**METROPOLITAN GOVERNMENT OF NASHVILLE AND DAVIDSON COUNTY**

**STAFF RECOMMENDATION**  
**111 4<sup>th</sup> Avenue South**  
**October 16, 2013**

**Application:** New construction-additions, Alterations  
**District:** Broadway Historic Preservation Zoning Overlay  
**Council District:** 19  
**Map and Parcel Number:** 09306400800  
**Applicant:** John Werne, Architect  
**Project Lead:** Sean Alexander, sean.alexander@nashville.gov

**NEW NORTH ELEVATION**  
FACING MERCHANT'S PARKING LOT

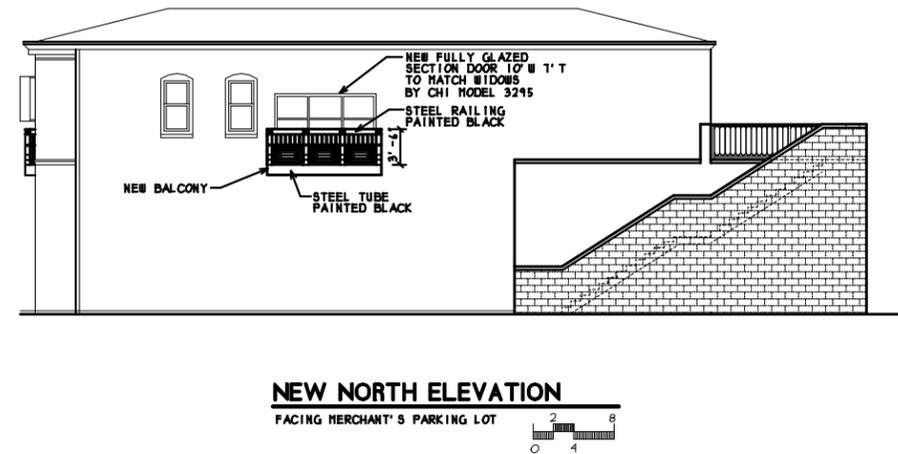
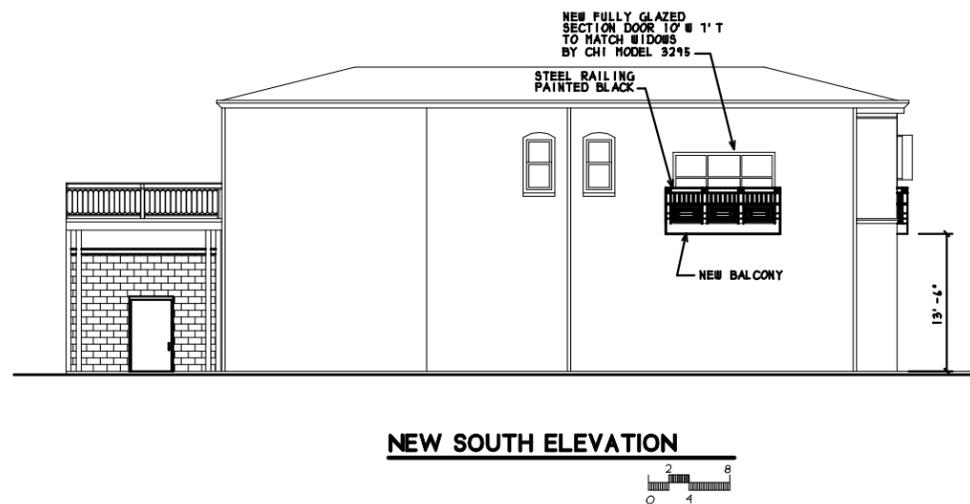
The design guidelines state that historic window openings and original walls “should be retained” and that window openings “not original to the building should generally not be introduced.” Staff finds the original wall planes and window openings to be significant features relating to the architectural styles, materials, and methods of construction of the late 19<sup>th</sup> Century, the period when the majority of the surviving historic buildings in downtown Nashville were developed. For this reason, staff finds that the proposal to alter the window openings and remove significant amounts of wall material would have an adverse effect on the historic character of the building the district, and would not meet guidelines II-H.1, H.5, and I.1 nor the Secretary of Interior Standards.

The addition of balconies does not meet guideline II-I.2. and guideline III-2.3, as they would damage or obscure historic features of the building and the design guidelines specifically state that addition of balconies is not appropriate.

**Recommendation:** Staff recommends disapproval of the application, finding it does not meet the design guidelines for the Broadway Historic Preservation Zoning Overlay.
